Supernova Range – 44B101 High Voltage Probe

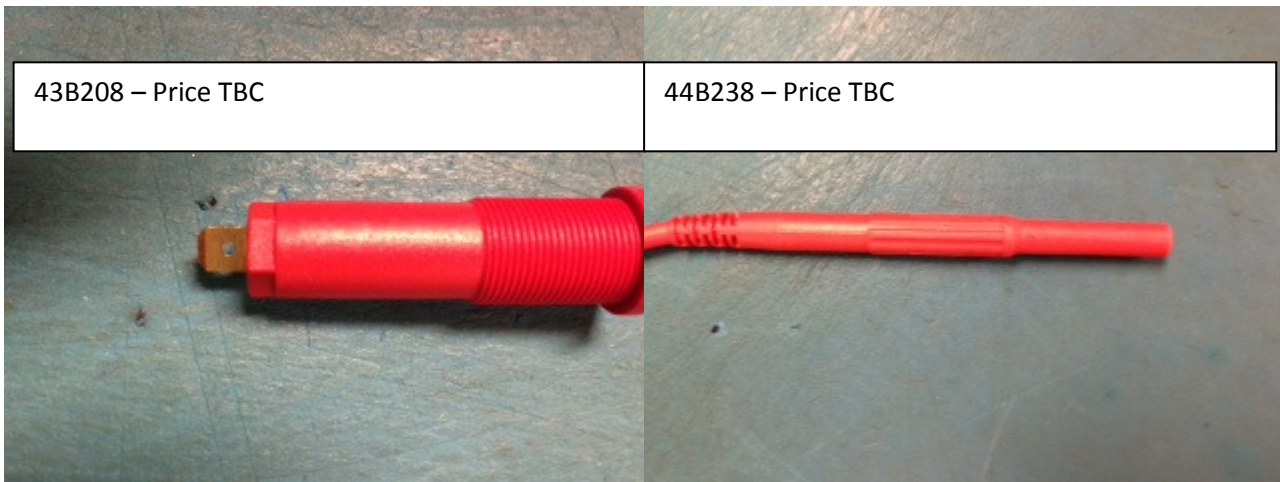
- 1) Supernova Part Numbers Range From 283A910 To 937.
- 2) Due to a change by the manufacture of the connector probe used on the 44B101, Seaward Electronic Ltd have been left with no alternative but to change the design of our 44B101 lead to 44B238.
- 3) This means that all units with a serial numbers prior to **31E-0650** cannot use the new 44B238 lead with the existing 4mm red socket used in the Supernova.
- 4) If you are purchasing a 44B238 lead from Seaward Electronic Ltd you will also need to purchase a 4mm Red Socket 43B208, as you will need to replace the existing 4mm Red Socket.
- 5) Also the same goes if you are replacing just the 4mm Red socket, you will also need to change the 44B101 lead as well.

- 6) **Safety Note:** - As you are opening up the unit and changing the socket Seaward Electronic Ltd recommend that the unit is fully calibrated.
